TITLE: **COMBINED USE PERMIT/SPECIAL PERMIT NO. 19A,** requested by 70th Street Properties, to adjust the side yard setback to zero feet for parking at the Lincoln Surgical Center, located at 1710 South 70th Street.

LINCOLN CITY/LANCASTER COUNTY PLANNING STAFF REPORT

PROJECT #: Use/Special Permit #19A - Lincoln Surgical Center

PROPOSAL: Adjust side yard setback for parking

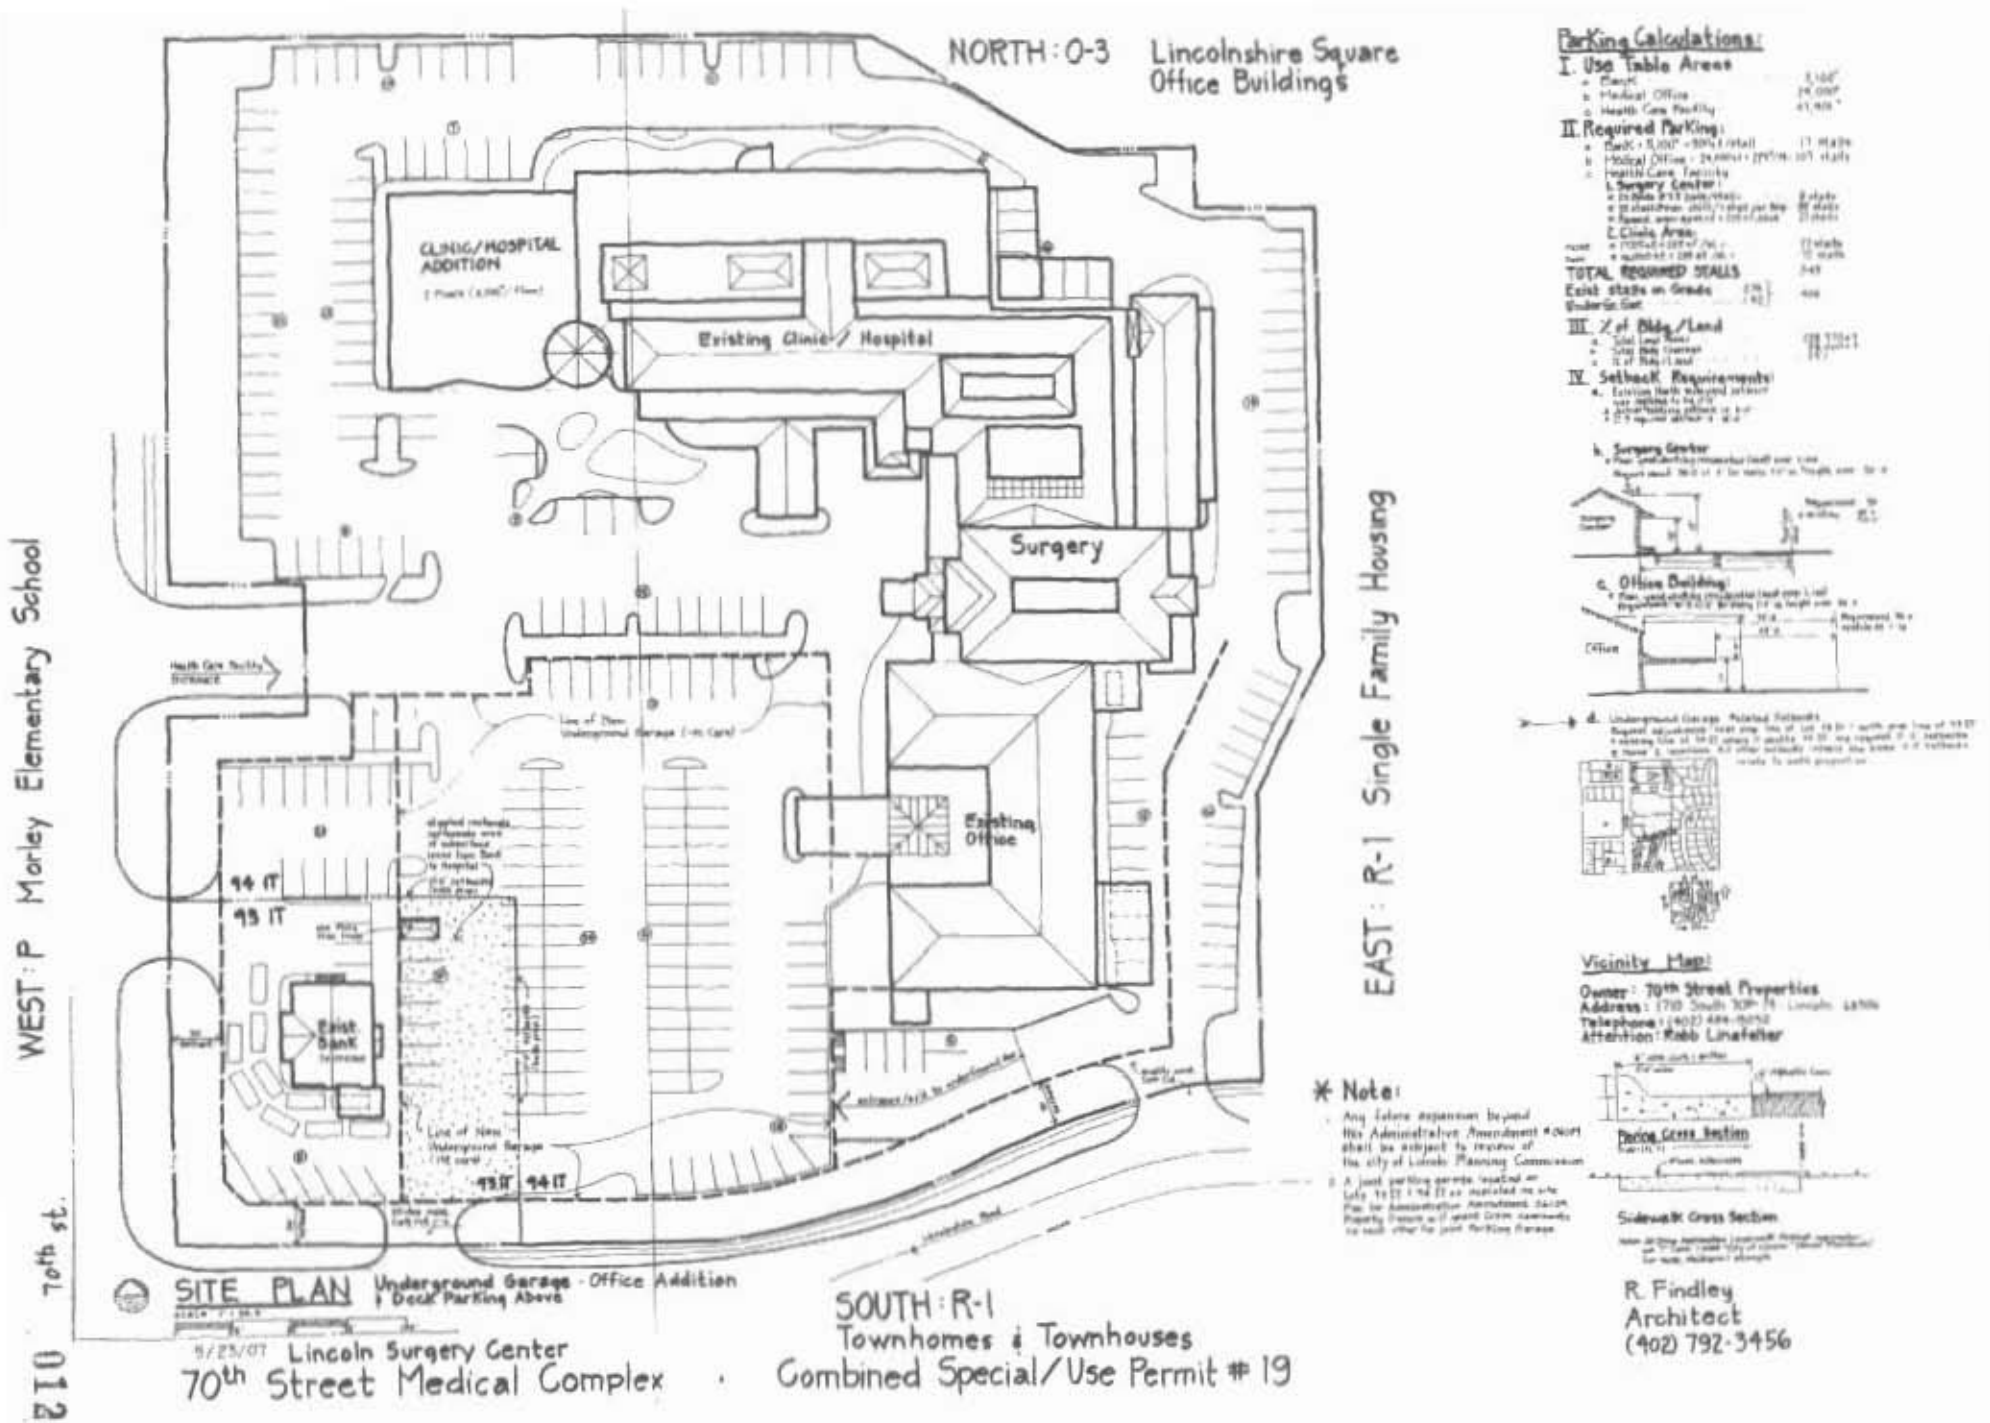
4. The building permit review for the underground parking facility noted two deficiencies with the revised surface parking layout. First, it showed hospital parking spaces encroaching into side yards which is prohibited in the O-3 zoning district unless adjusted by City Council. Second, a number of the hospital's parking spaces were shown located on the bank's lot. In this case, the Law Department has determined that parking lots and parking garages are not allowed uses in the O-3, B-2, B-5 and I-3 zoning districts, which means that parking cannot be located on a lot under separate ownership.

5. A setback adjustment was granted with the original use permit adjusting the side yard setback to 5', but not to 0', so the purpose of this amendment is to adjust the side yard setback to 0' to allow parking up to the lot line. The adjustment only applies to the two yards where the two properties abut one another (the bank lot's north and east lot lines). Both yards are internal to the site and the impact upon any other properties is negligible. The setbacks for yards along all other lot lines remain 'as-is' and are not affected.

Carlson confirmed that the parking lot configuration will not change. This just makes it legal as it sits. Will explained that if this amendment is not approved, the 5' side yard would have to be maintained. If this amendment is approved, parking will be allowed to go up to and cross over the setback.

Carroll asked the staff to talk about the employees entering the parking structure off of the side street, i.e. Lincolnshire. Will showed the four access points on the map. There are sidewalks along the extent of 70th Street and along Lincolnshire. One advantage of this plan is that it does eliminate an existing driveway off of Lincolnshire. There is no traffic signal "at this intersection". One of the comments we hear is that some of the people leaving the facility and not being able to make a left turn, weed their way back through the neighborhood.

1. This approval adjusts the side yard setback to 0' where lots 93 and 94 abut one another.
